**LEE COUNTY HISTORIC PRESERVATION BOARD
OLD LEE COUNTY COURTHOUSE
2120 MAIN STREET
FORT MYERS, FL 33901
EAST ROOM**

AGENDA

A. COA 2011-00167 Wilson Residence, 16281 Quail Trail, Bokeelia, FL 33922

B. COA2011-00111, Goldpenny, 4725 Pine Island Rd, NW, Matlacha, FL 33993

Structural problems on the floor system of the second level

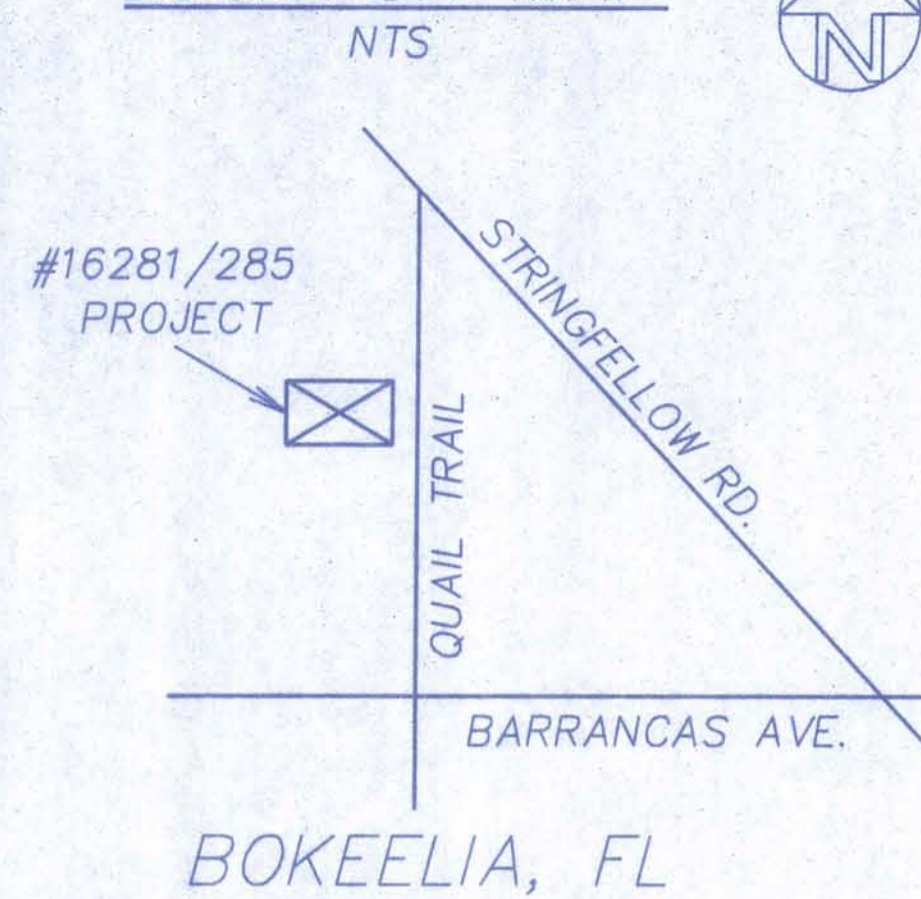
It was probably in the 1970s when the house underwent a major change as the expansive attic area was converted into another living unit (which included a bedroom, closet, bathroom and sitting area). The second floor was accessed by a set of wood stairs at the rear, located perpendicular to the house. (It is likely that originally the second floor attic area was accessed by interior stairs which were removed – the interior wall still features the “ghost of the stairs” on the rear wall – an unpainted area shaped like the stairs -- see attached photo.) While the mass and shape of the original roof was not changed, a flat roofed dormer was added to each side of the roof: one for the bathroom and the other for the walking closet. Unfortunately the entire conversion was done without adequate structural reinforcements for the additional load (see attached photos) and the house is currently structurally unsound.

EXIST./PROPOSED SITE PLANS
 WILSON RESIDENCE
 16281/285 QUAIL TRAIL, BOKEELIA, FL

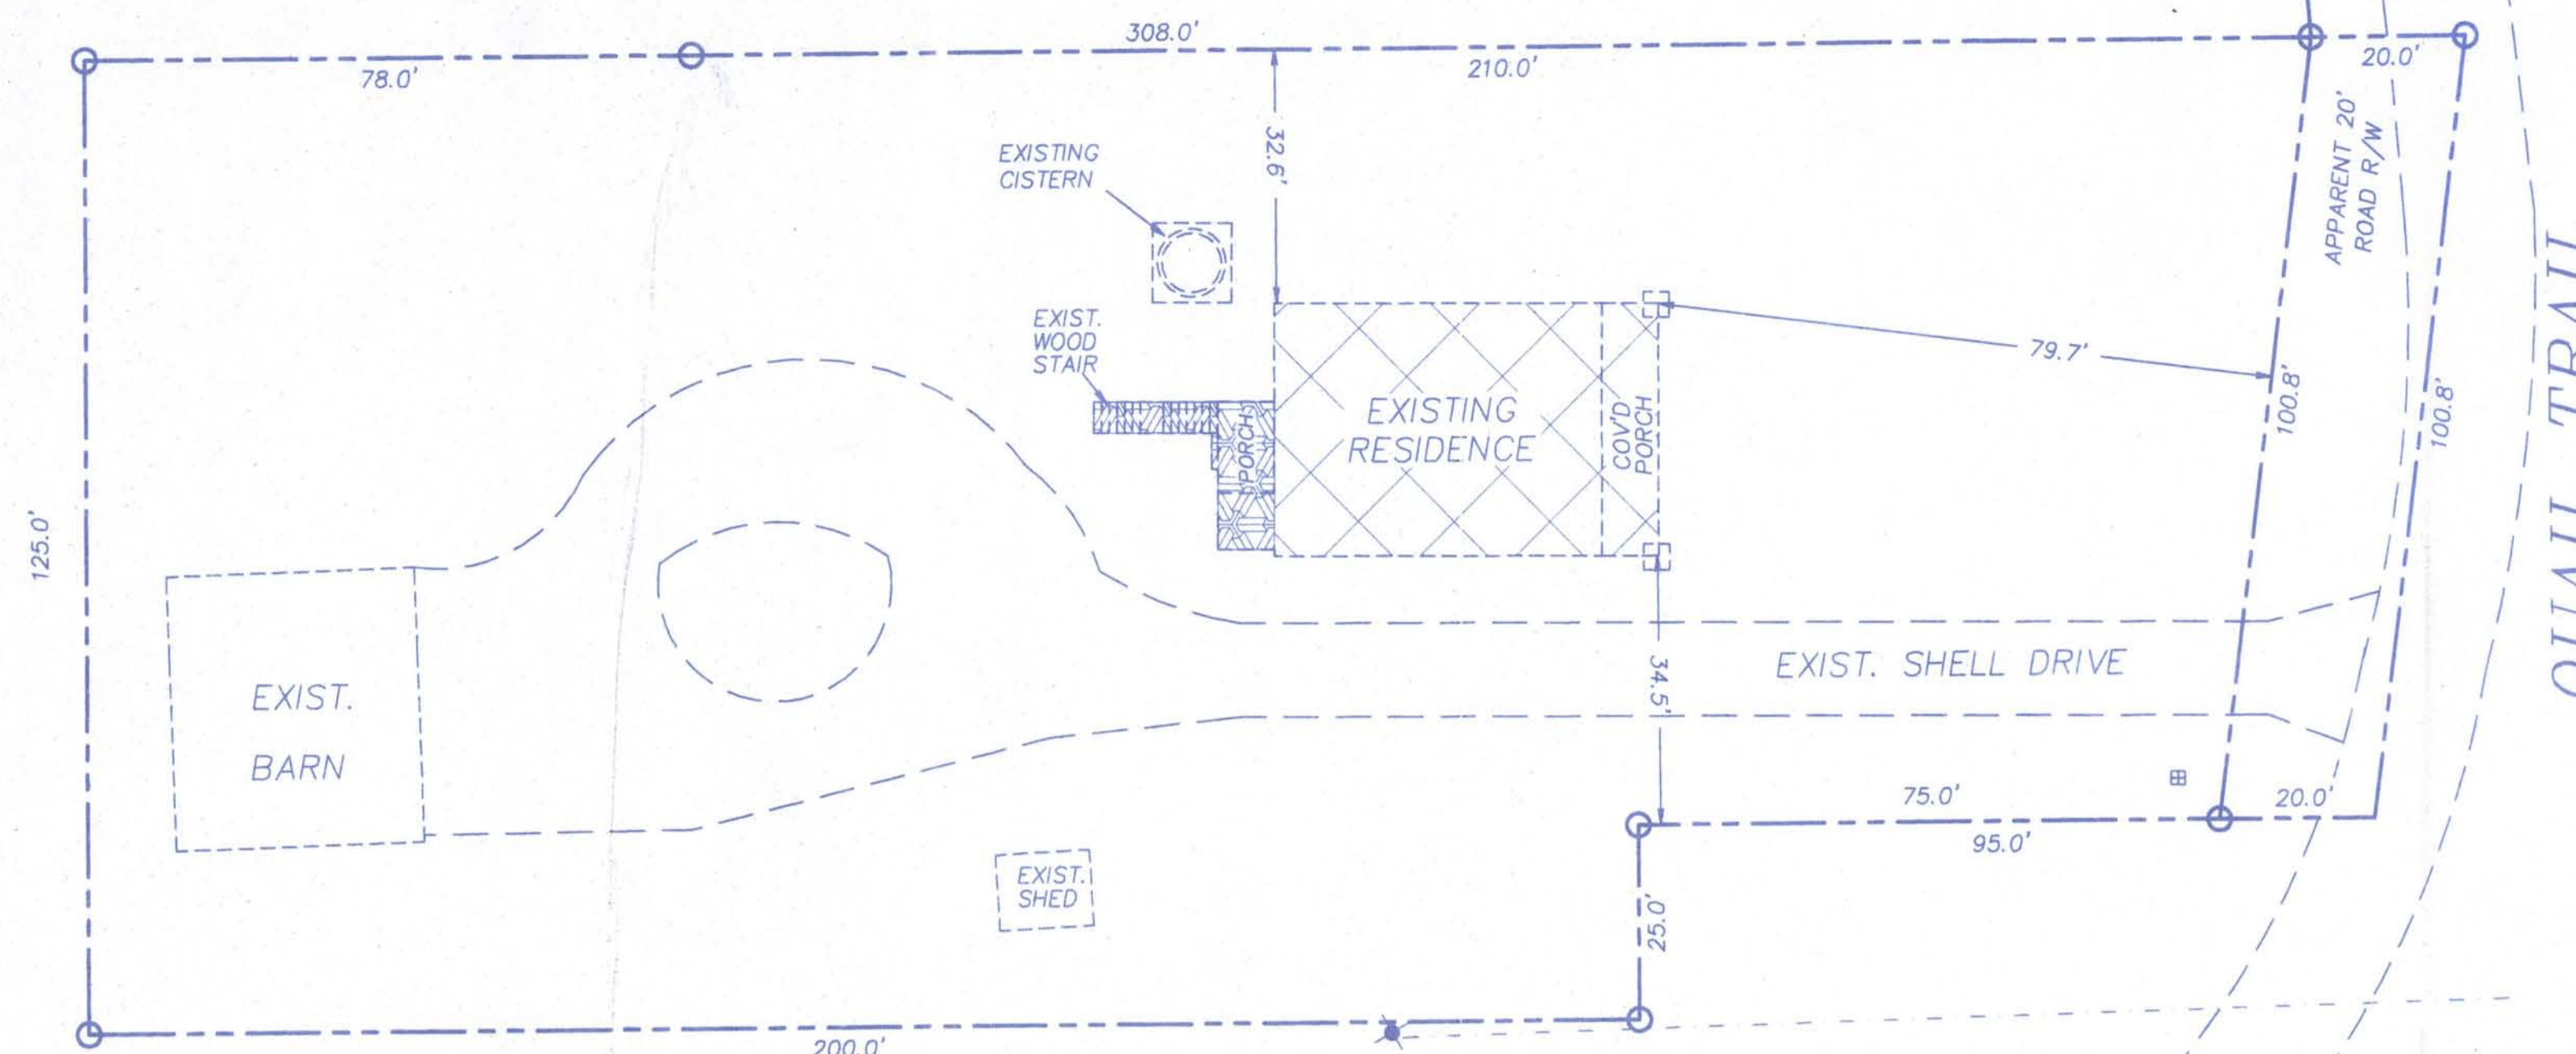
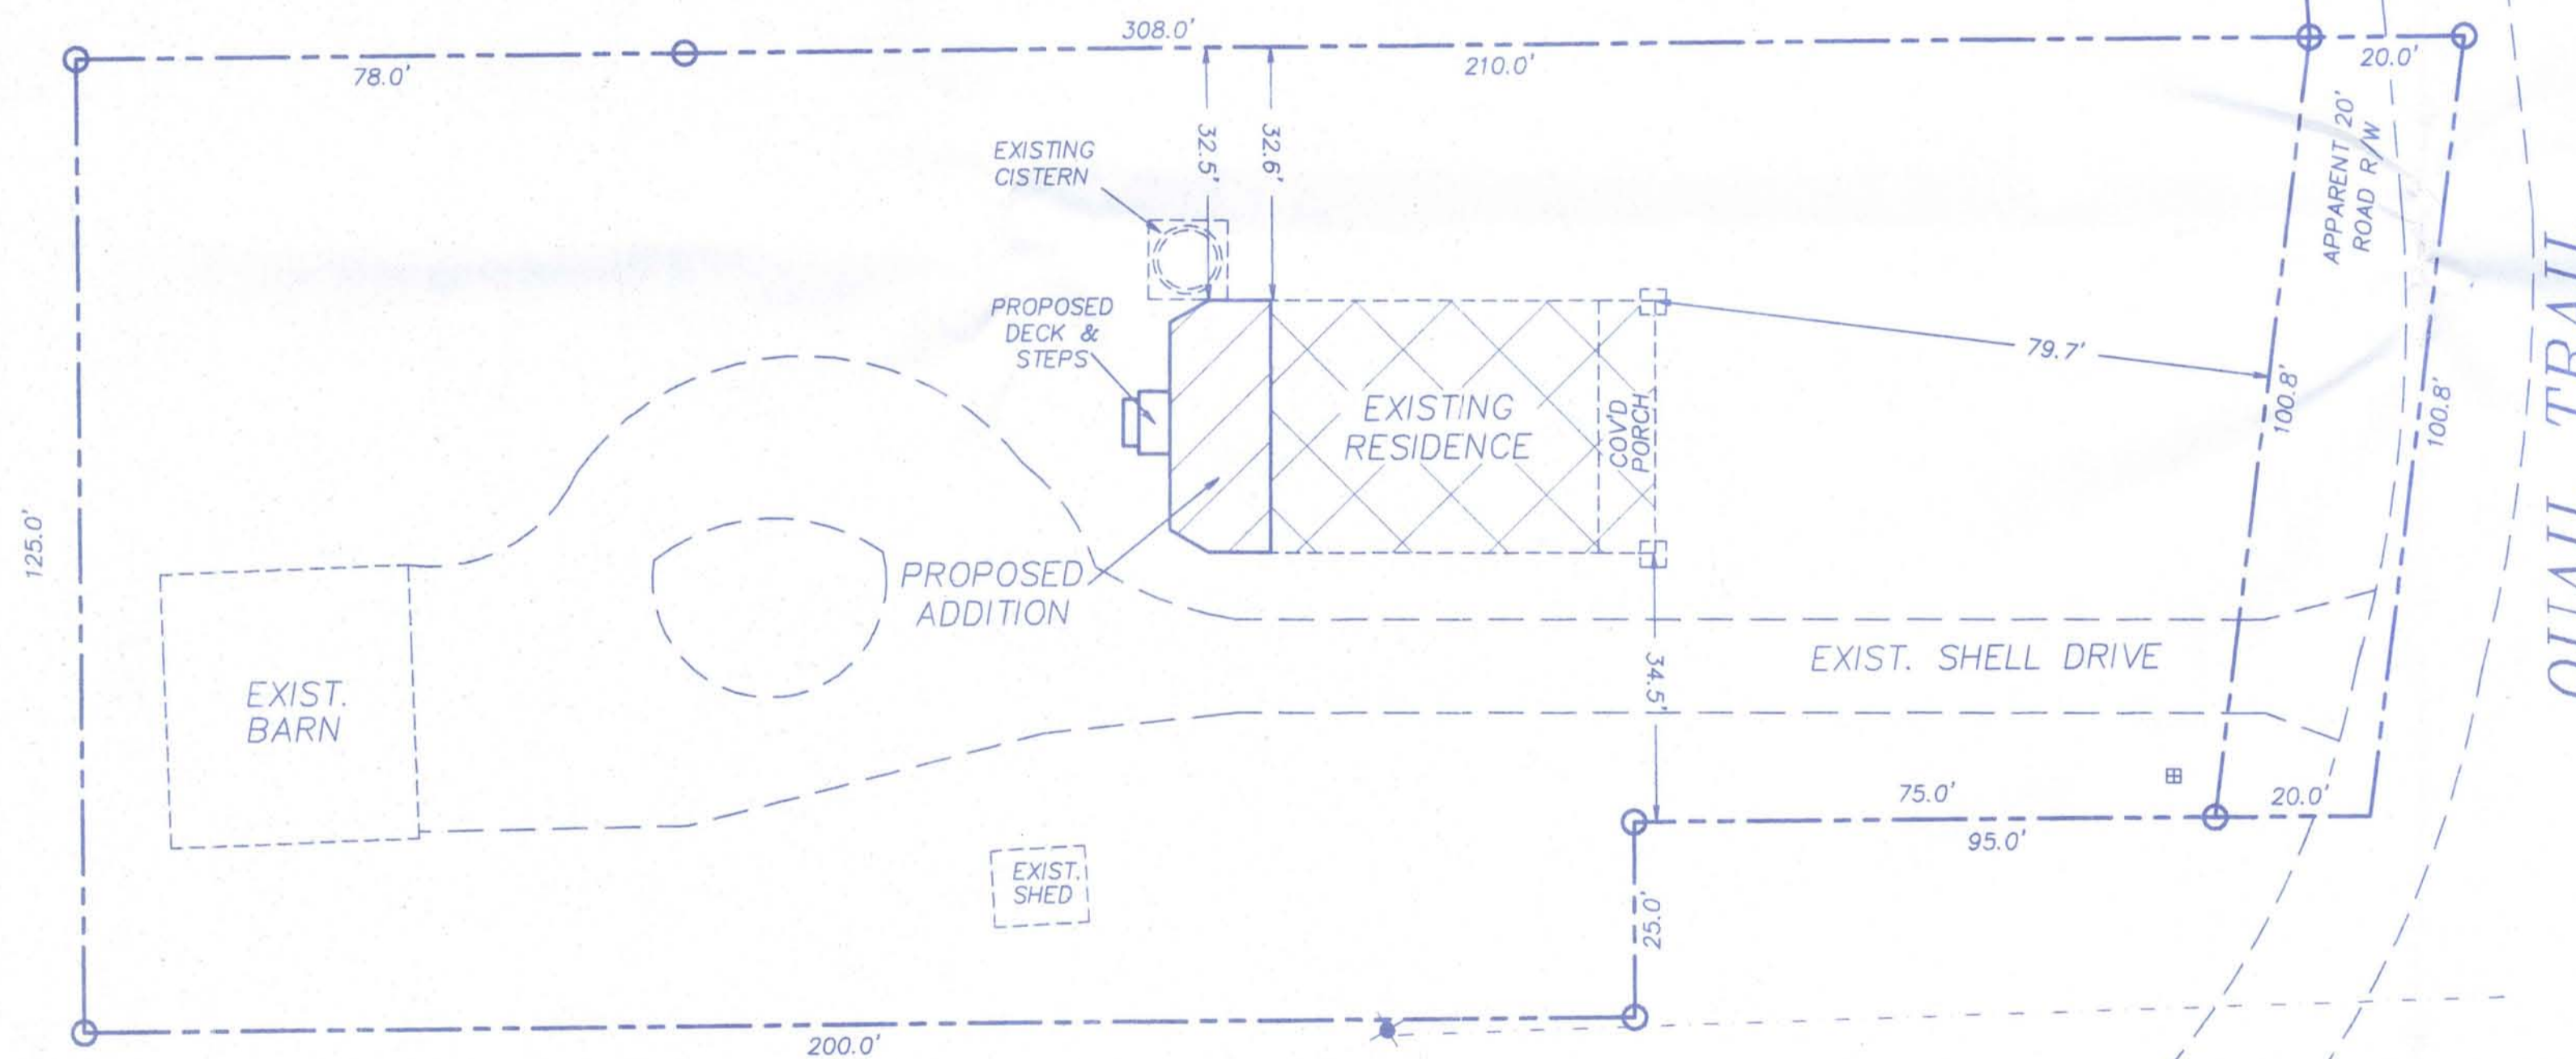
The proposed project: The major part of the proposed project deals with structurally stabilizing the existing house. Additionally minor changes will be made in order to accommodate a contemporary lifestyle. While the exterior of the front and side elevations (including the dormers) will remain unchanged, the applicant proposes to change the rear elevation.
